NOV_SCE_ATJ_ 20211202-01_Revised

NOTICE OF VIOLATION

Energy Safety Inspection Report

Report Name: ATJ_SCE_20221202-01_Revised
Inspection Date(s): December 2, 2021
Inspector: Anthony Trujillo
Utility: Southern California Edison
Attention: Erik Takayesu, Vice President Asset Strategy and Planning

Structure ID: 45377945E

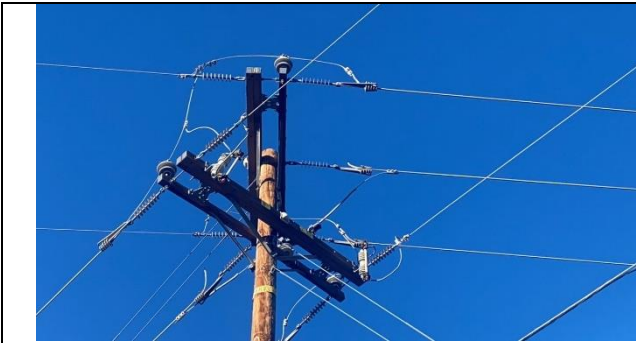
Item1IA1Img1: Pole ID

Structure ID: 862693E

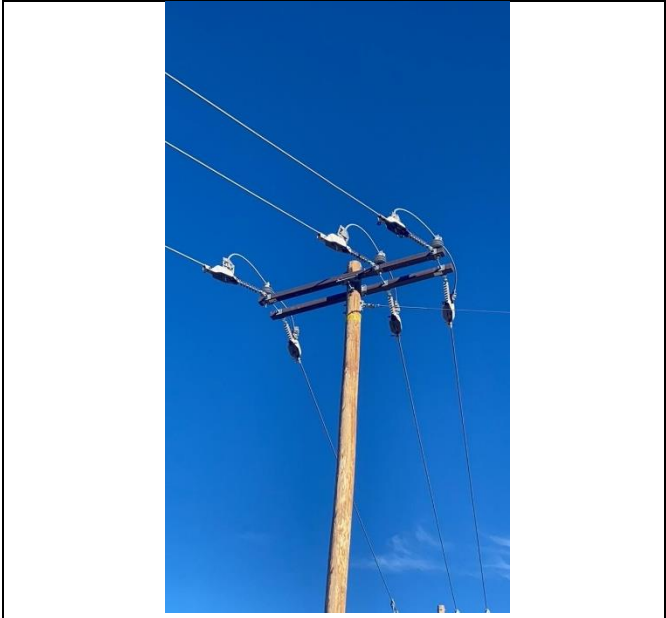
Item4IA1Img1: No vibration dampers

Structure ID: 4724215E

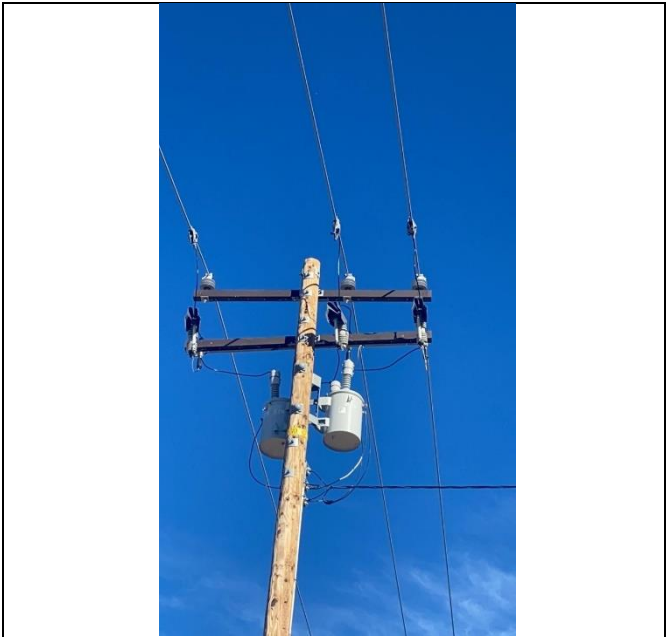
Item6IA1img1: No vibration dampers

Structure ID: 4308816E

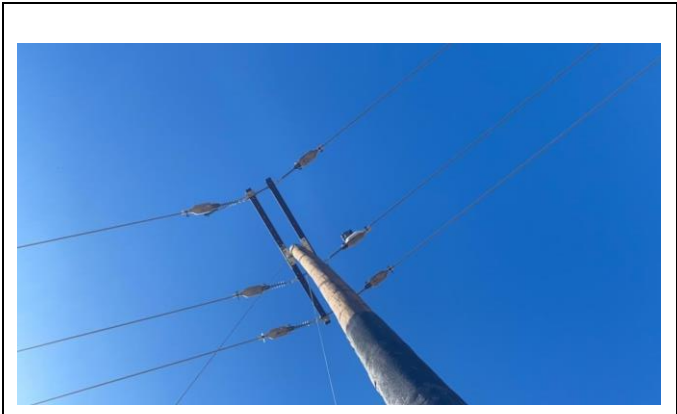
Item12IA1Img1: No vibration dampers

Structure ID: 4789750E

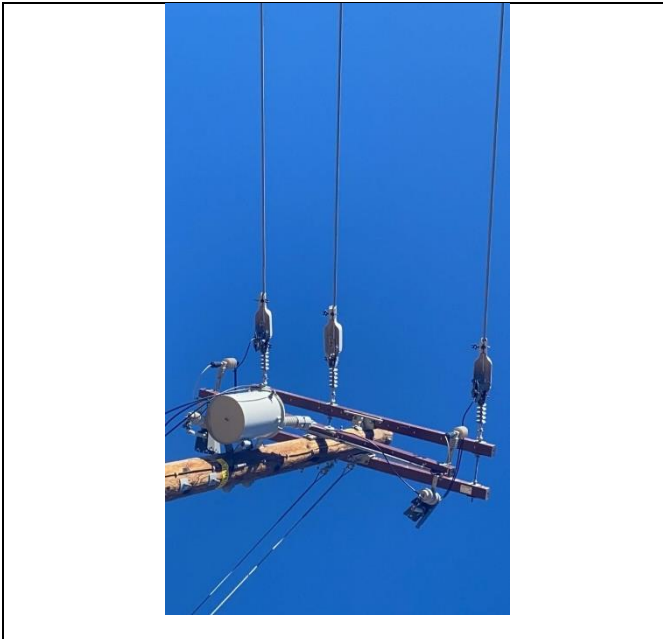
Item14IA1img1: No vibration dampers

Structure ID: 4568486E

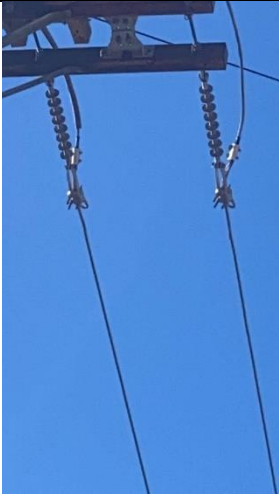
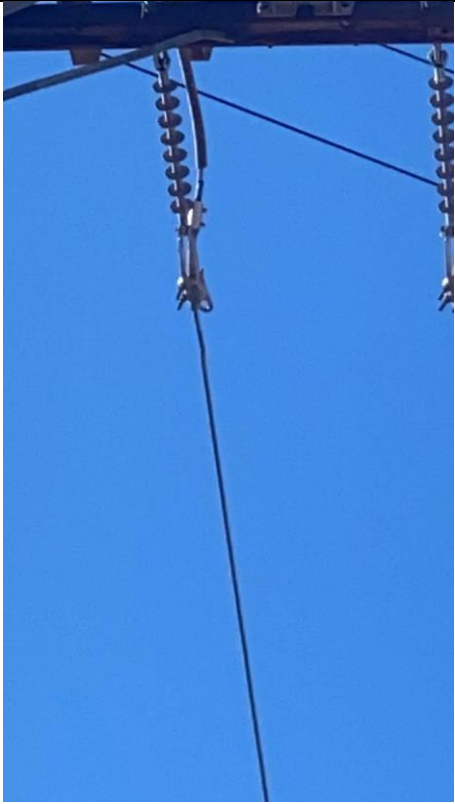
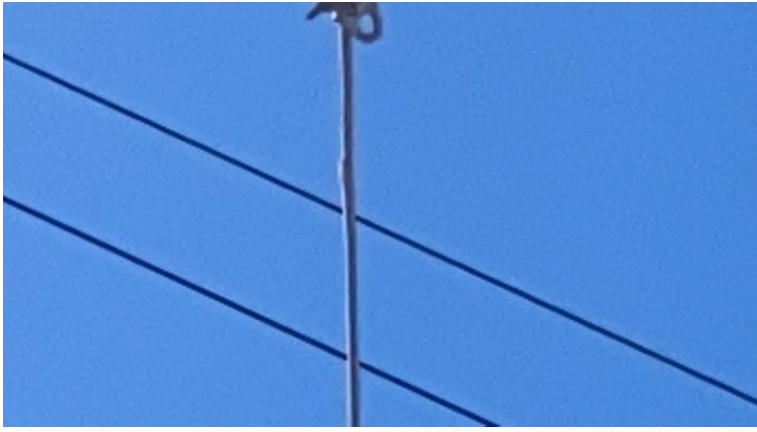
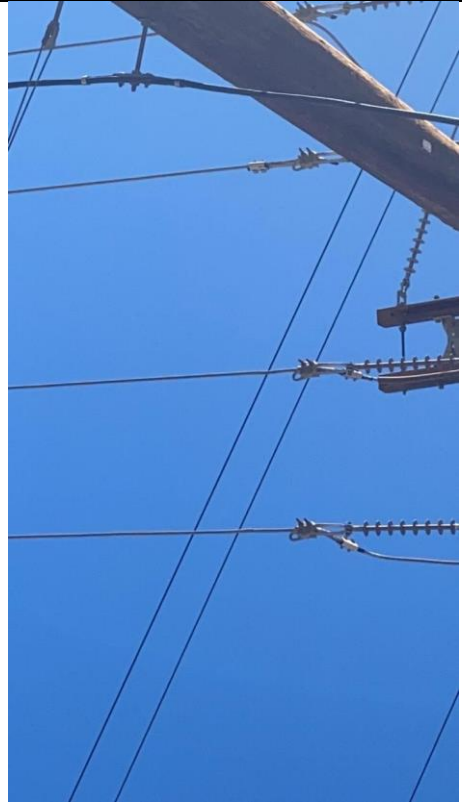
Item15GImg3: Bare wire on all phases closeup

Item15IA1Img1: Bare conductor

Item15CD5Img1: Close up of phase bird caging

Item15CD5Img2: Overall view, bird caging on bottom phase
